**NOTICE OF SPECIAL MEETING  
CITY OF SOUTH PADRE ISLAND  
SHORELINE TASK FORCE**

**Beachfront Construction Certificate & Dune Protection Permit in the City of South Padre Island**

**Site Address:** 5106 & 5108 Gulf Boulevard, South Padre Island  
**Legal Description:** Lots 1B, 1C, 1D & 1E, Block 156, Padre Beach Section X  
**Lot Applicant:** Access SPI, LLC c/o Alfredo G. Hernandez  
**GLO ID No.:** BDSPI-18-0099b

TO: Shoreline Task Force  
Natalie Bell, General Land Office  
FROM: Brandon N. Hill, Shoreline Management Department Project and Program Manager  
DATE: August 13, 2018  
RE: 5108 and 5106 Gulf Boulevard, Lots 1E & 1D, Padre Beach, Sec X

WOODEN WALK WAY  
SECTION A-A'  
N.T.S.

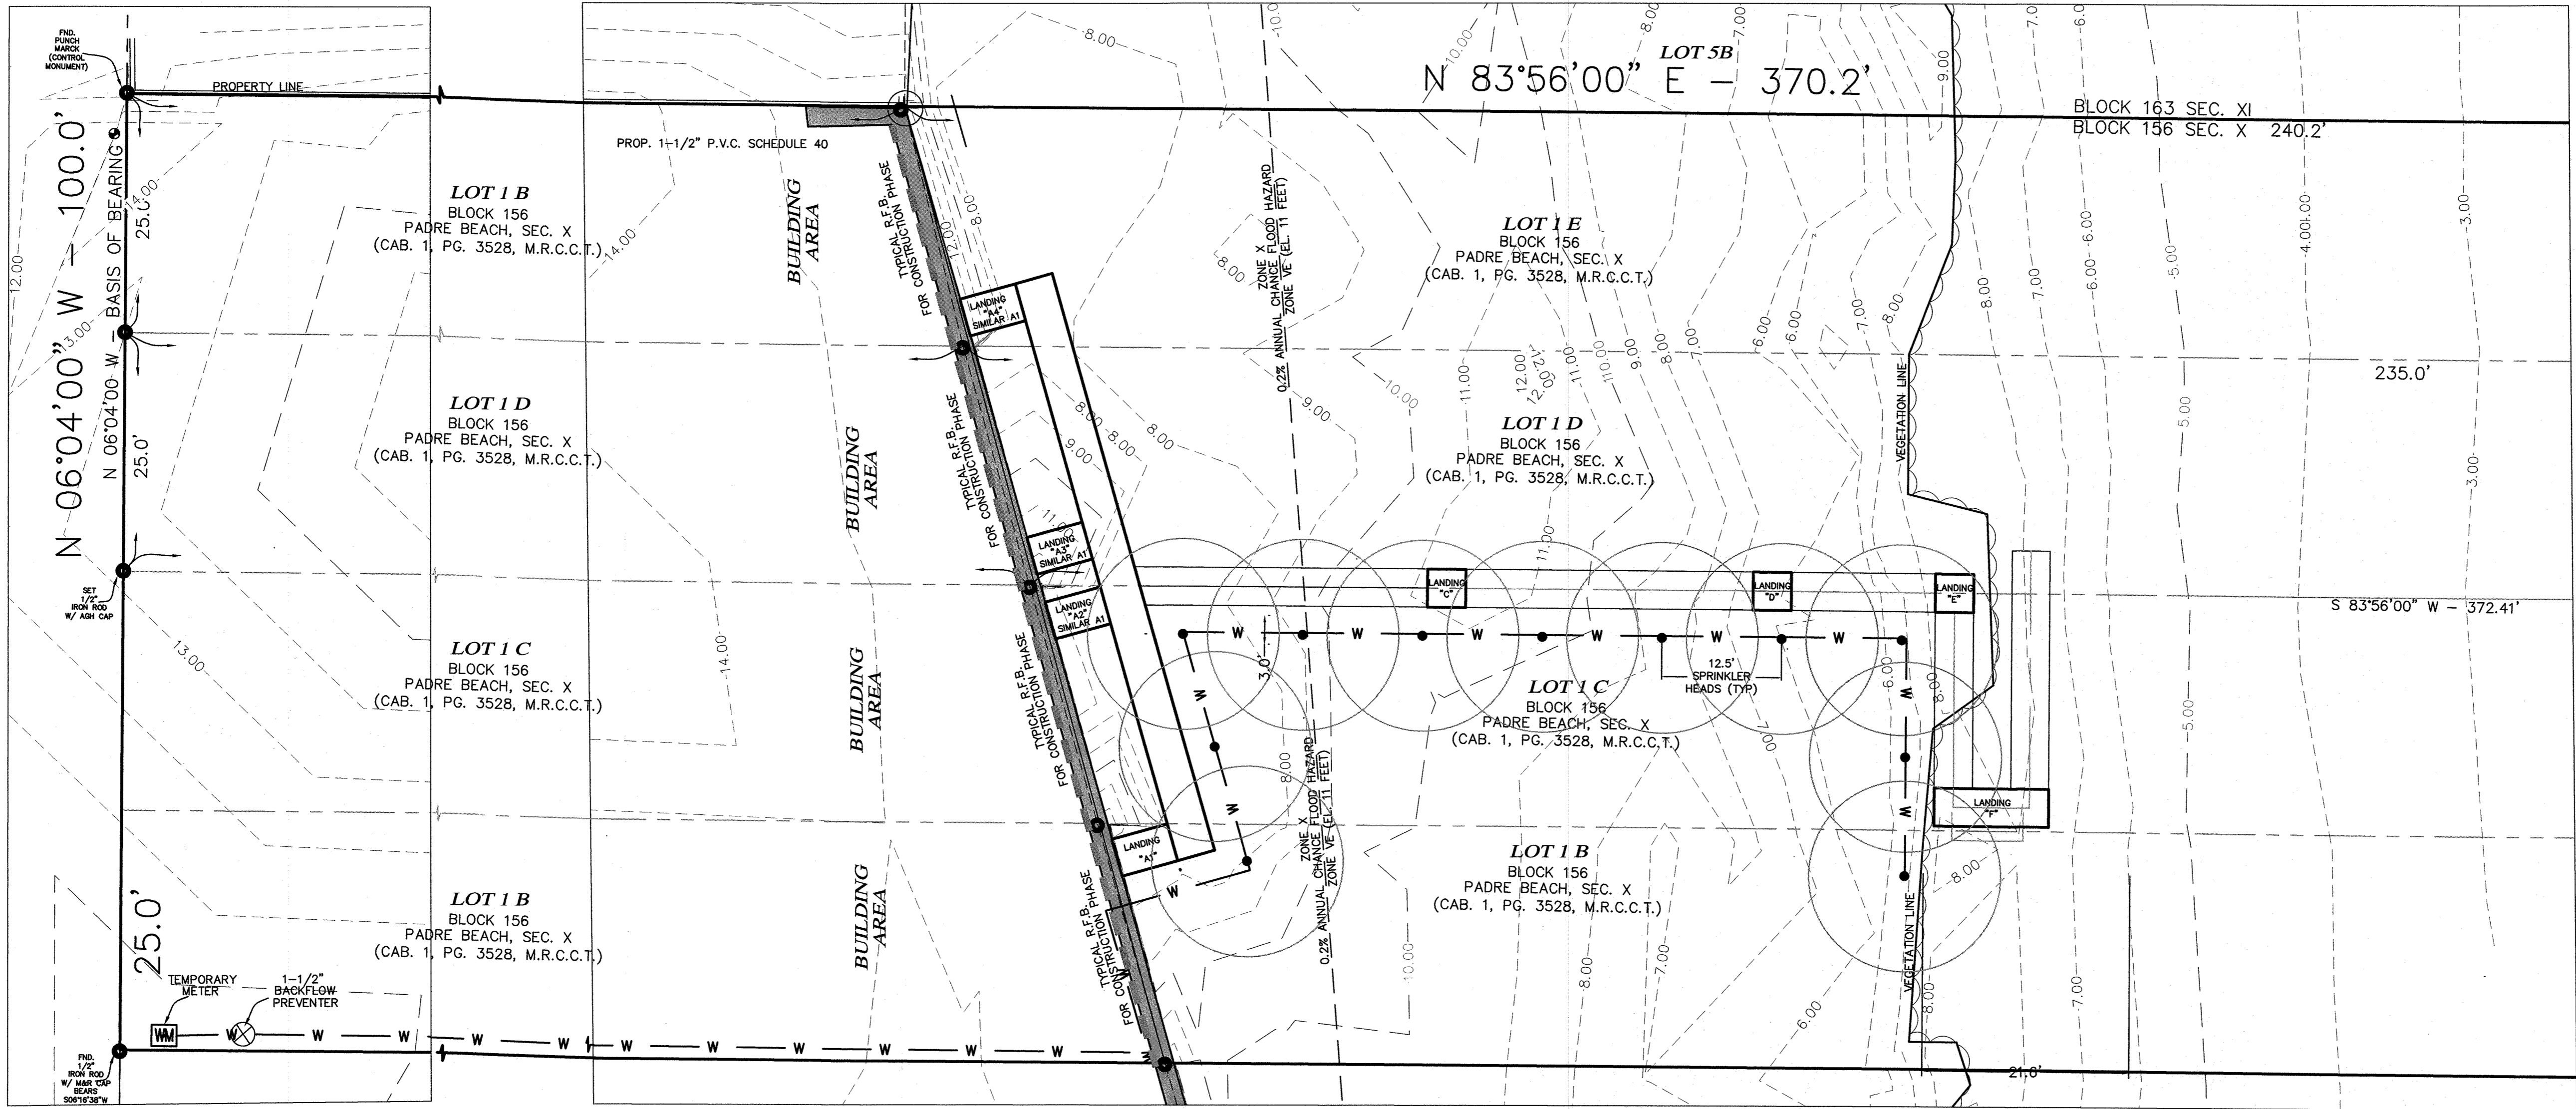
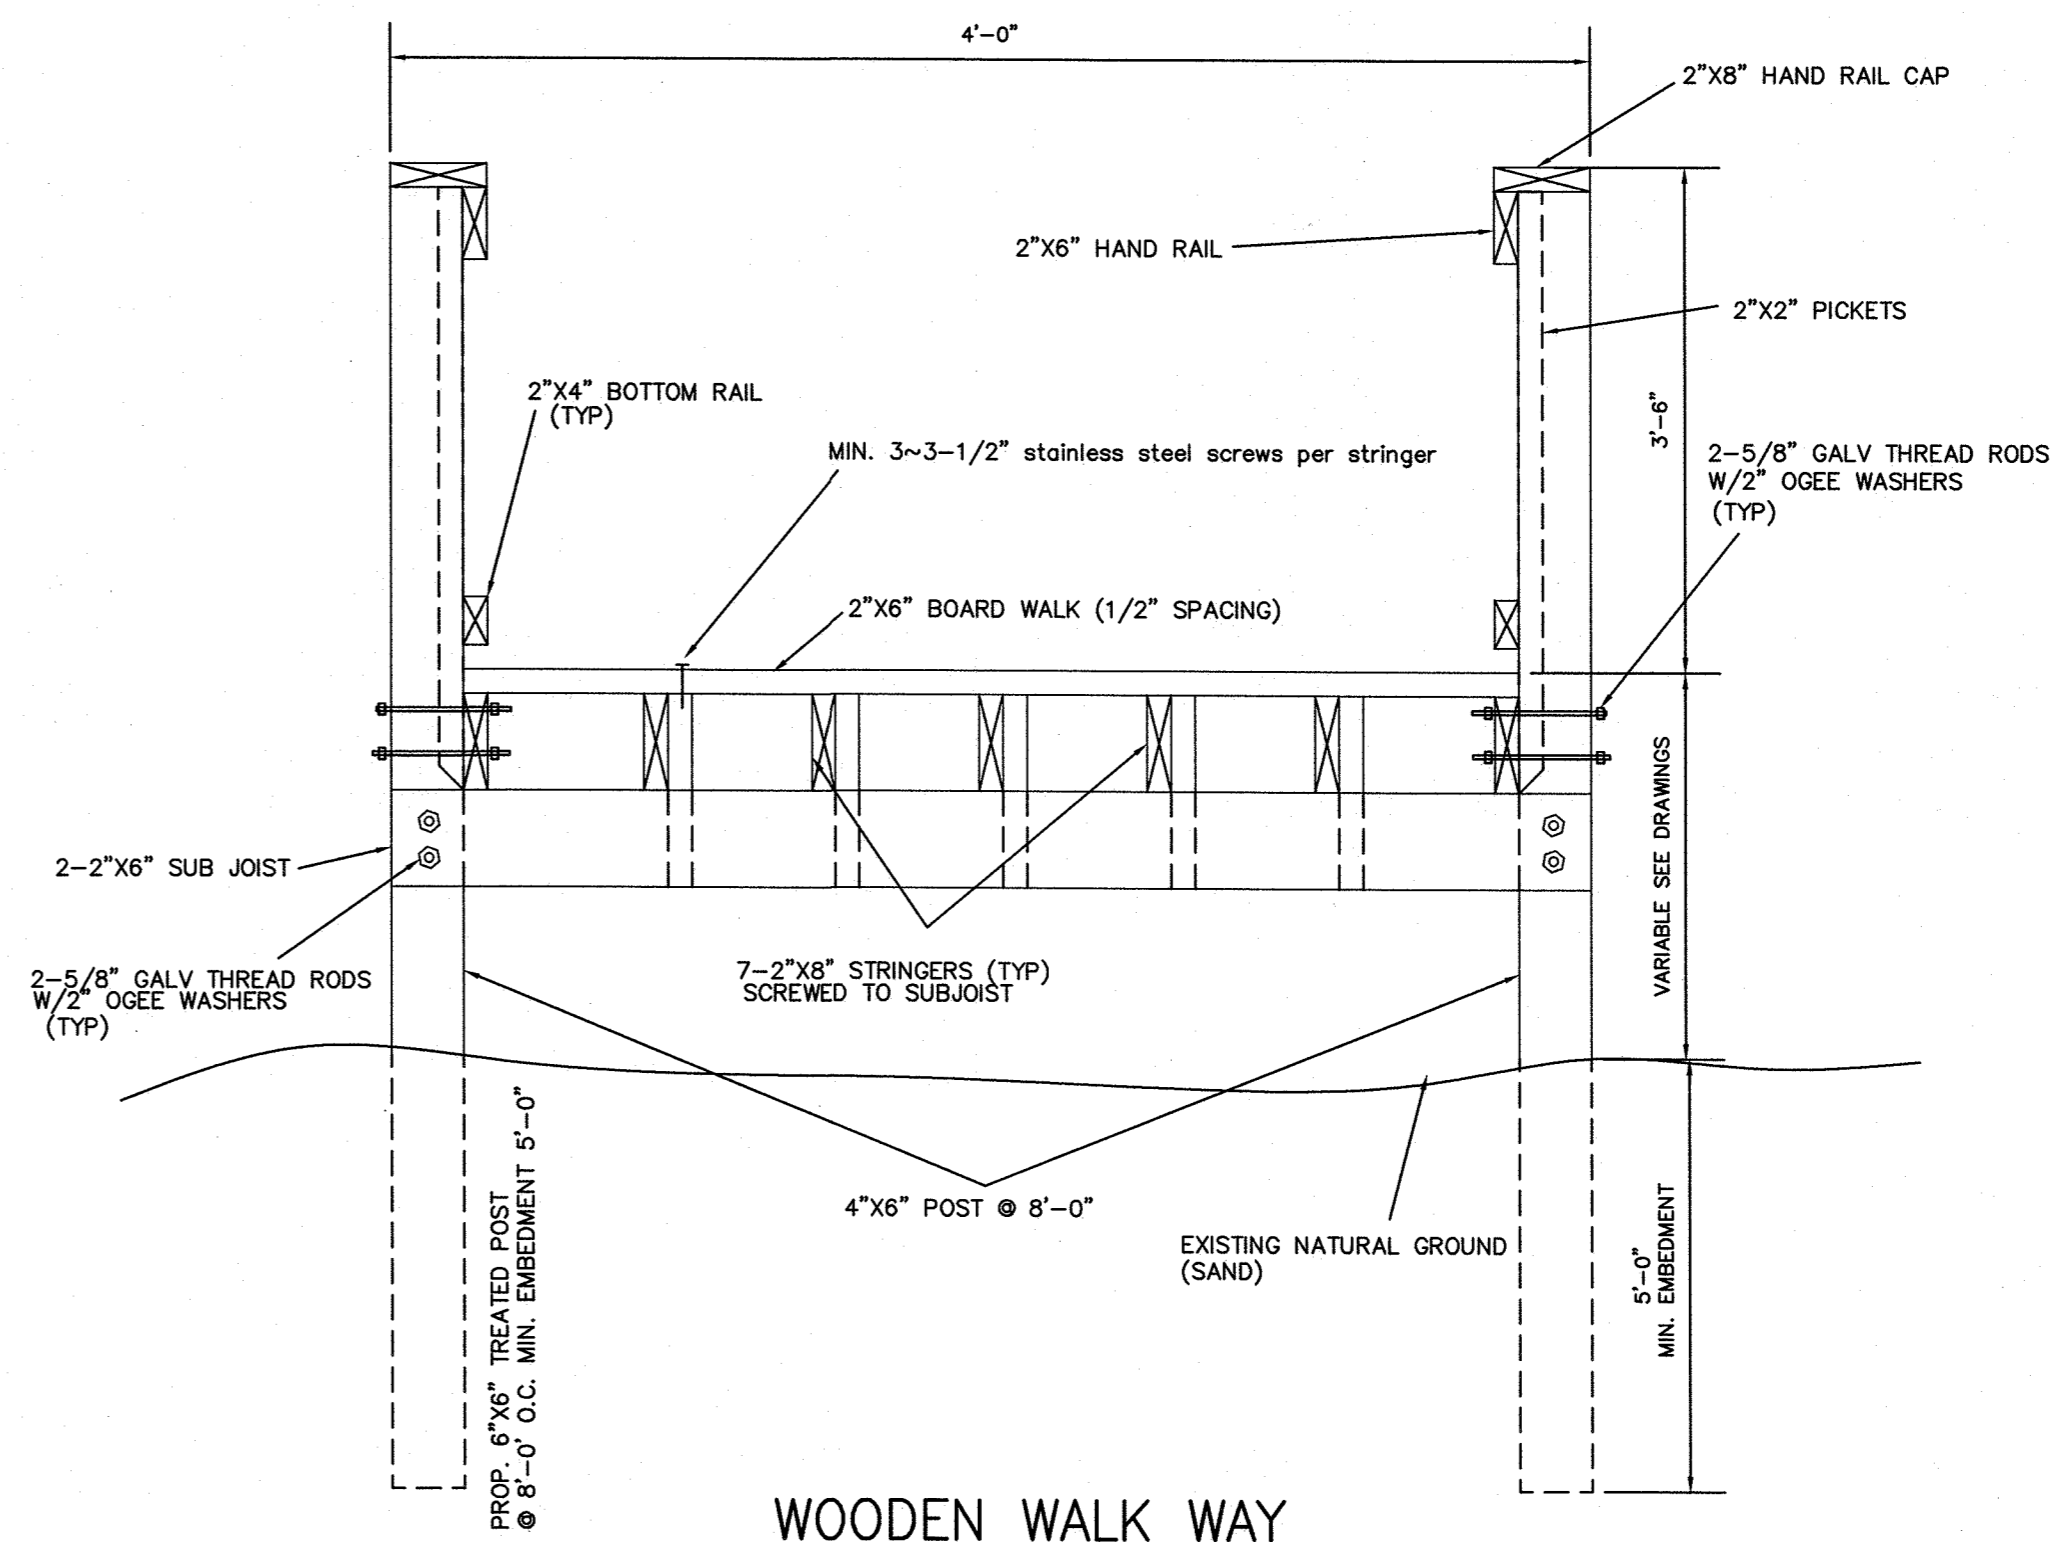
- The deck of the walkover must be of sufficient elevation to allow for the growth of dune vegetation and the migration of dunes to the greatest extent practicable.<sup>4</sup>

- The proposed dune walkover should be constructed to allow rain and sand to pass through the decking. The GLO recommends placing the slats that form the deck of the walkover at least ½-inch apart.

- The walkway height above the dunes should be at least one to one and a half times its width (three feet minimum) to allow sunlight to reach vegetation underneath.

## TEMPORARY IRRIGATION PLAN

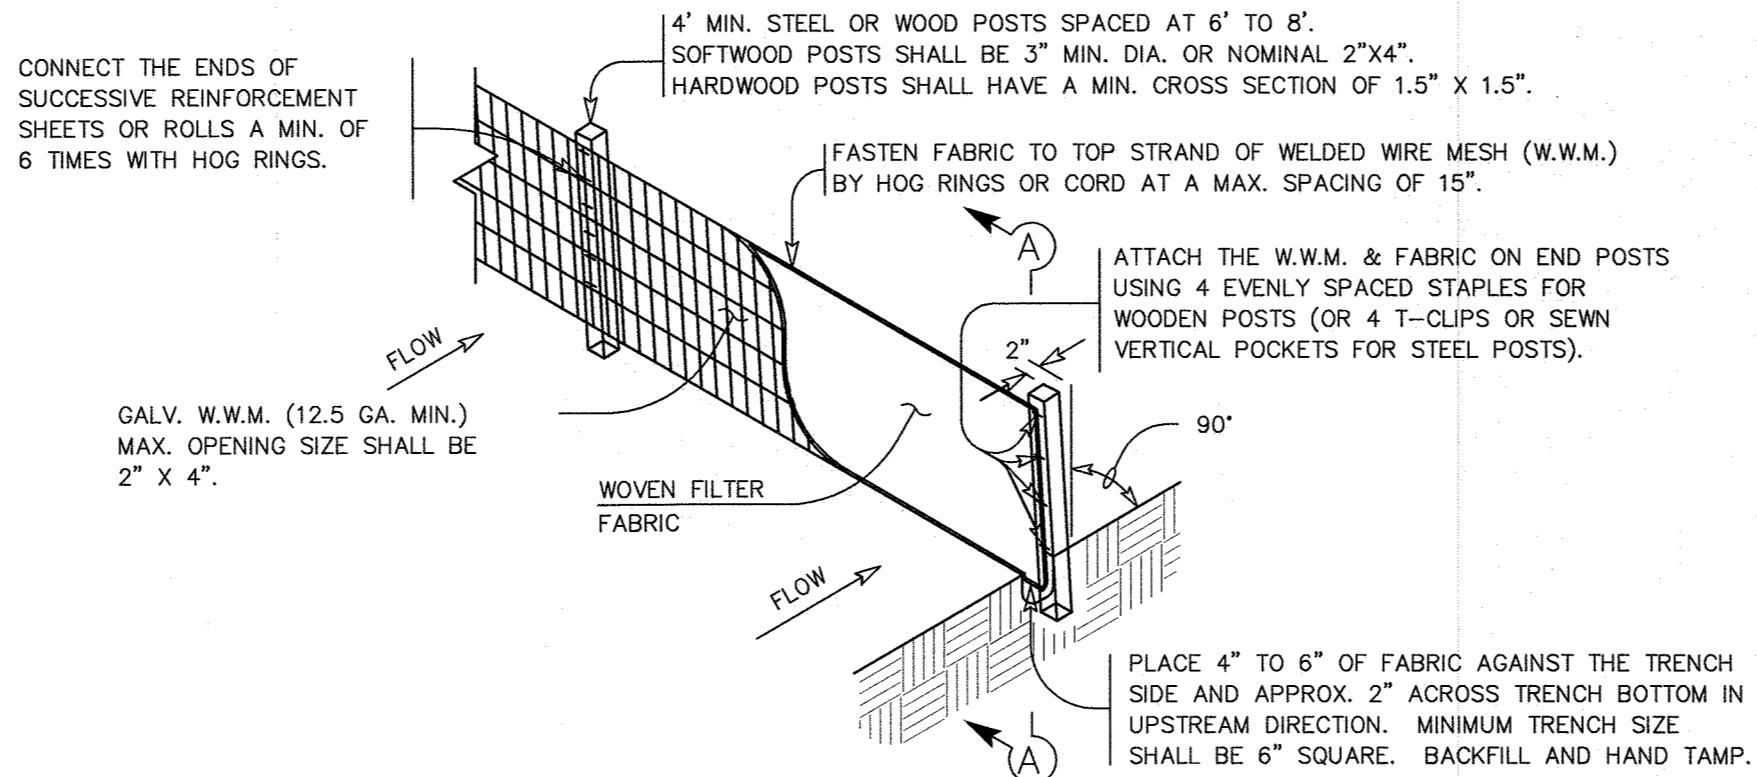
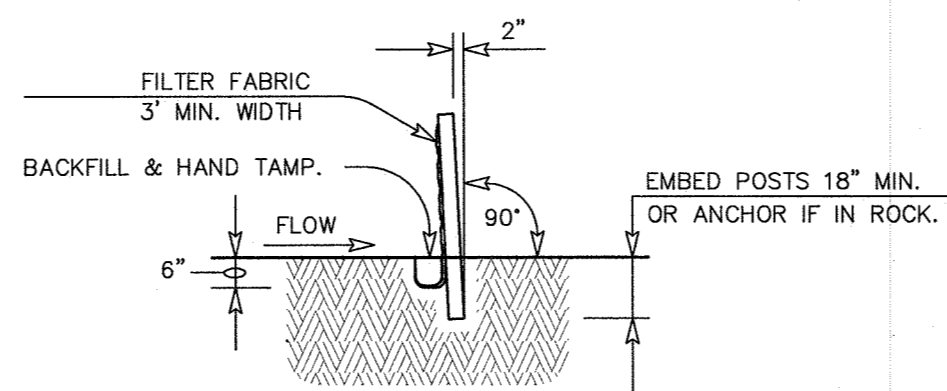
City Staff recommends approval with the stipulation that as per the submitted plans the applicant will mitigate the damage 1:1 in the area under the walkover by planting the impacted area with dune vegetation such as Sea-oats or Bitter Panicum.
